**CITY OF ISSAQUAH
DEVELOPMENT SERVICES
DEPARTMENT DEVELOPMENT
COMMISSION**

STAFF REPORT

FILE NO.: Community Conference: COM15-00002

PROJECT: Silverado Memory Care

3 East Elevation
SCALE: 3/32" = 1'-0"

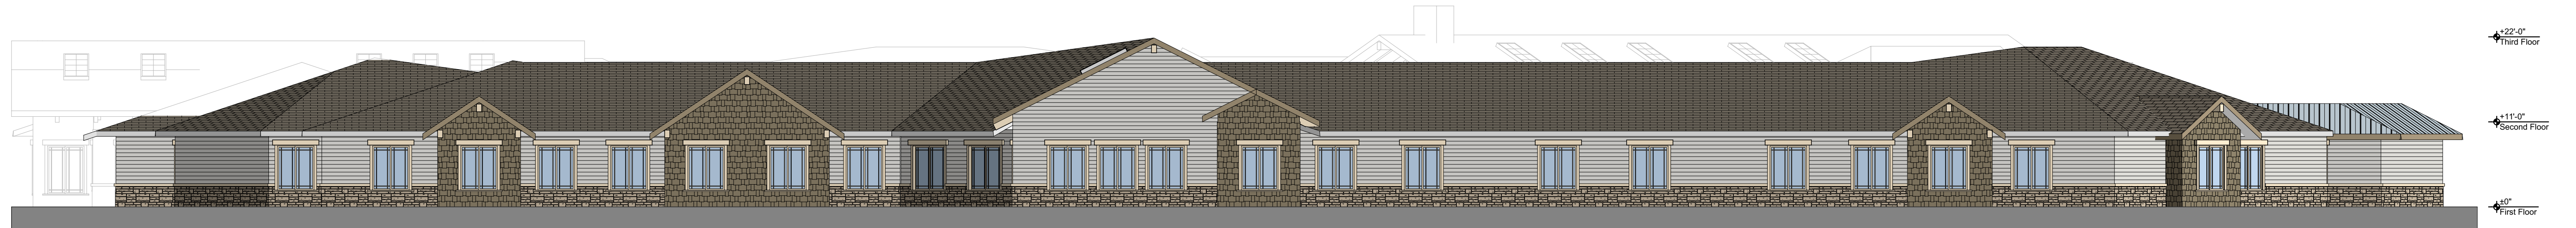
The facility is designed as a one story building and is fairly modulated. Some further modulation may be advisable on the eastern elevation facing the creek and upland residents as the wall is fairly plain. Landscaping adjacent to the building edge may also be used to add texture to the eastern facade.
